**REF NO: 054/2024/PMID/MCWAP2/RFB NOTICE 48**

***ABSTRACTION WORKS, PUMPING STATIONS, RESERVOIRS, PIPELINE, RELATED  
MULTIDISCIPLINE WORKS, ANCILLARY WORKS***

TCTA acknowledges receipt of the requests for clarification listed in the attached table. The response to each request for clarification is provided in the attached table.

In addition to the above, the Contractor believes that the sump should be located at gridline A. This will simplify the routing of the pipework to discharge into the flushing canal. See marked up drawing (2B-C7-200) below:

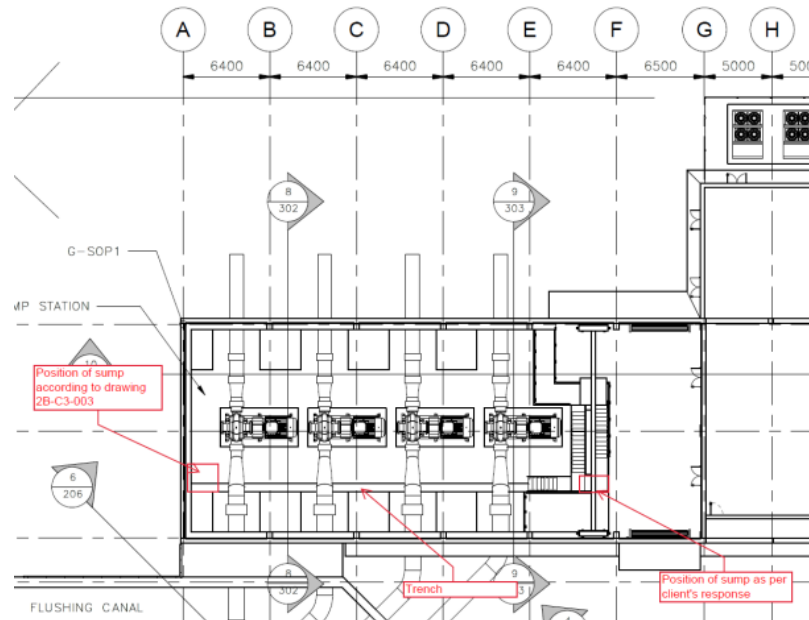
**Client to advise.**

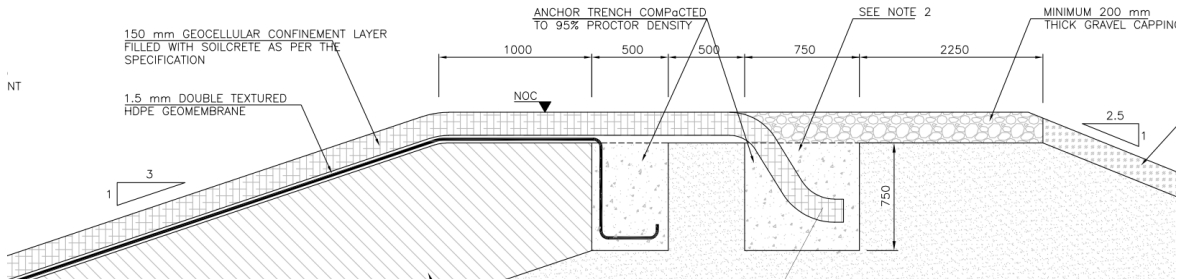
5	Please explain what material Anchor Trench is in drawing 2A-C6-010? It corresponds to “Anchoring to concrete structure” in the BOQ.	The drawing referred to is correct and applies to pay item No’s 2.D2.4.9, 2.D2.4.10 and 2.D2.4.11 where the HDPE liner and confinement are anchored onto the earth embankment. The material to be used in the anchor

trenches will likely be sourced and selected from the balancing dam construction excavated material

Pay item No's 2.D2.4.6, 2.D2.4.7 and 2.D2.4.8 refer to the anchoring of the liner and confinement layer to concrete structures. The applicable drawing number for anchor details into concrete structures is drawing no 2A-C6-011.
